## HIA Addendum

In June 2017 a Heritage Impact Assessment report was completed for submission to the Department of Planning and Environment by the TCSA as part of the DA material for the proposed African Precincts development (NSW State Significant Development – Application No. 8008). Following reviews by the Department and the Office of Environment and Heritage, a number of issues were identified for clarification. Also, as part of the TCSA's response to the Departmental reviews, various components of the earlier proposal have been reconsidered. As a result of this, there are various changes to the proposal such that the earlier assessed potential for heritage impact has needed to be amended to reflect the revisions to the proposed design.

Plan showing the status of the early zoo path system and proposed modifications with respect to the present DA. (Plan courtesy of Jean Rice, TCSA and TZG/Ethos Urban)

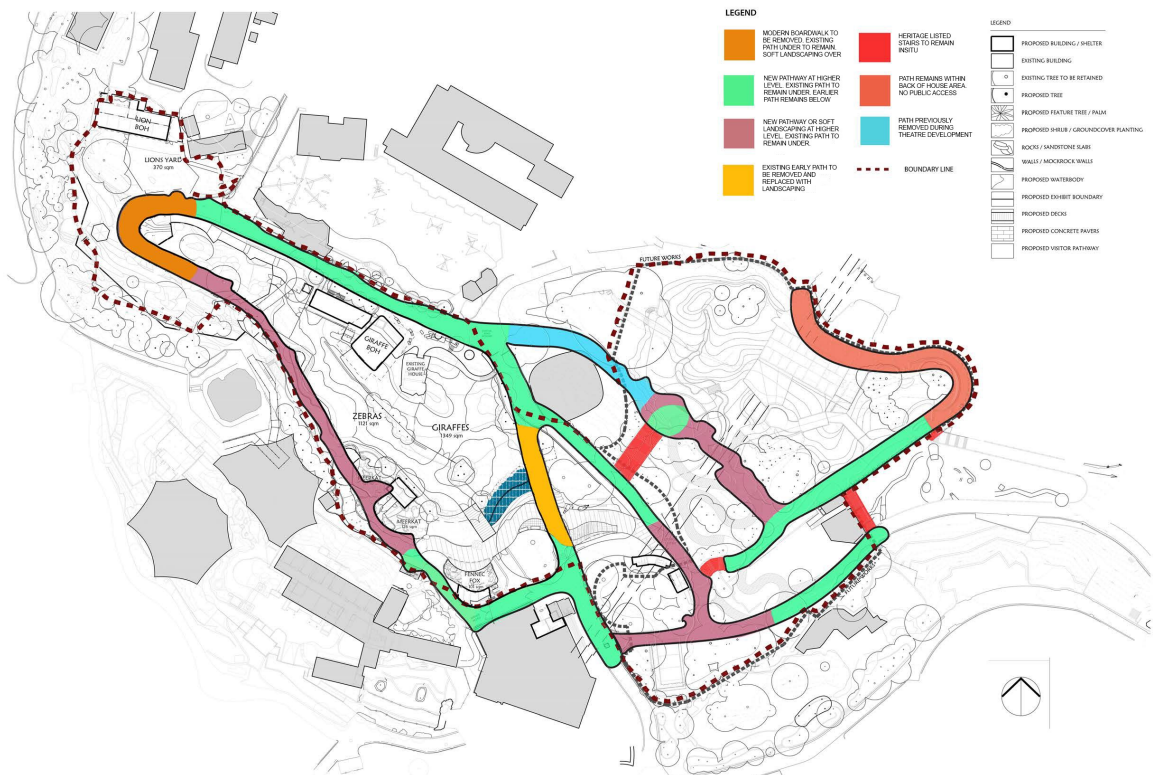
In response to the Department's request, a plan (see below) has been prepared showing the status of the original pathway system that falls within the present DA area. In most cases the existing paths would remain – either at surface level or under proposed new paths. Only a short section of the original pathway would be removed as part of this DA which is that south of the Centenary Theatre.
